Agenda Item # 2

SUB-003479-2025

501 Bel Air Subdivision

- Subdivision approval to create one (1) legal lot of record from one (1) metes-and-bounds parcel.

DETAIL SITE PLAN

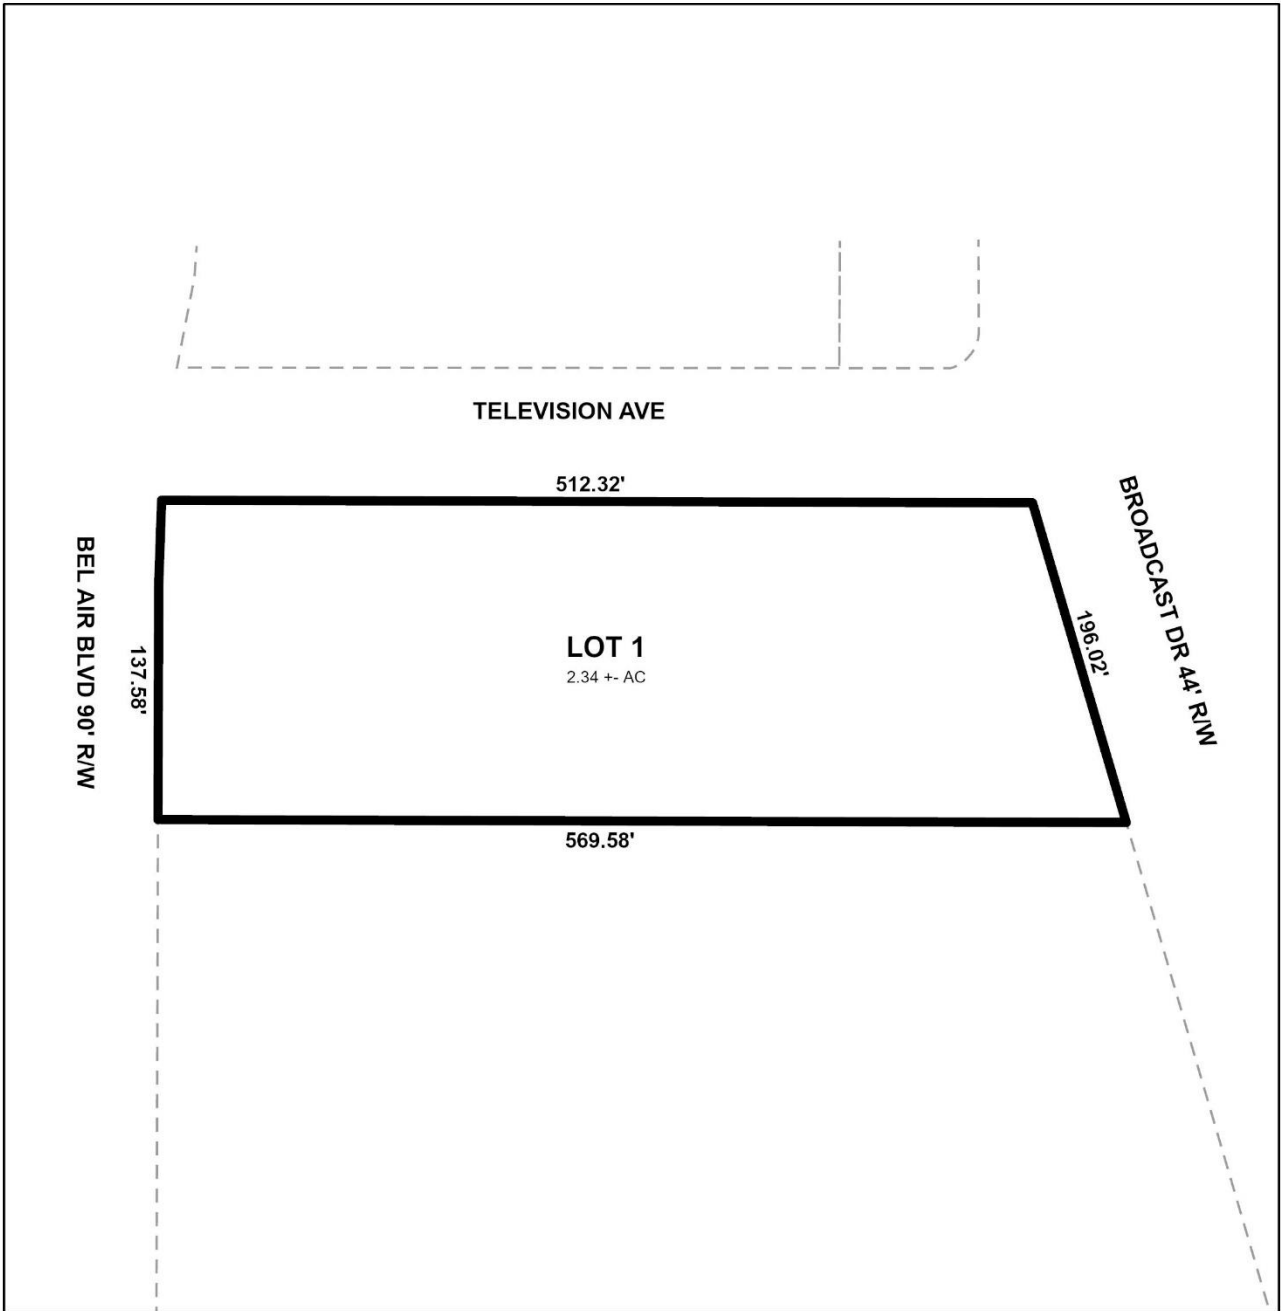
The lot has frontage along Bel Air Boulevard, a Minor Arterial Street with an existing 90-foot-wide right-of-way at this location. It also fronts Television Avenue and Broadcast Drive, both minor streets with curb and gutter improvements, each requiring a minimum 50-foot-wide right-of-way. The preliminary plat depicts sufficient right-of-way along Bel Air Boulevard, a substandard 44-foot-wide right-of-way along Broadcast Drive, and does not provide right-of-way information for Television Avenue.

Internal mapping data and parcel records indicate that sufficient right-of-way likely exists along Television Avenue. Therefore, if approved, the plat must be revised to clearly depict either the existing right-of-way width or dedication sufficient to provide a 50-foot-wide right-of-way, whichever is greater.

Previous subdivisions approved in the vicinity have been required to dedicate right-of-way sufficient to provide at least 25 feet from the centerline of Broadcast Drive. Accordingly, if approved, the plat should also be revised to depict dedication sufficient to provide 25 feet from the centerline of Broadcast Drive, in compliance with Section 6.C.9. of the Subdivision Regulations.

The proposed lot is situated at the intersections of Bel Air Boulevard and Television Avenue, and Television Avenue and Broadcast Drive. Section 6.B.12. of the Subdivision Regulations requires curb radii of not less than 20 feet, or as otherwise approved by the City Engineer. Section 6.C.6. further requires property lines at street intersections to be arcs with radii of at least 25 feet, or as approved by the City Engineer and the Traffic Engineering Director. Therefore, the plat should be revised to depict dedication of corner radii sufficient to comply with these requirements.

Finally, the plat should be revised to illustrate the required 25-foot front yard setback along all street frontages, in accordance with Article 2, Section 64-2-10.E. of the UDC and Section 6.C.8. of the Subdivision Regulations, adjusted for any required dedication.

1. Retention of the right-of-way along Bel Air Boulevard on the Final Plat, as depicted on the preliminary plat;
2. Revision of the Final Plat to depict the minimum existing right-of-way and, if less than 50 feet, dedication to provide 25 feet from the centerline of Television Avenue;

3. Revision of the Final Plat to depict dedication sufficient to provide 25 feet from the centerline of Broadcast Drive, unless a waiver of Section 6.C.9. of the Subdivision Regulations is granted by the Planning Commission;

4. Revision of the Final Plat to depict dedication of a 25-foot corner radius at the intersections of Bel Air Boulevard and Television Avenue, and Television Avenue and Broadcast Drive, or as otherwise approved by the City Engineer and the Traffic Engineering Director, unless waivers of Sections 6.B.12. and 6.C.6. of the Subdivision Regulations are granted by the Planning Commission;

6. Revision of the Final Plat to illustrate the required 25-foot front yard setback along all street frontages, in compliance with Article 2, Section 64-2-10.E. of the UDC and Section 6.C.8. of the Subdivision Regulations, adjusted for any required dedication;
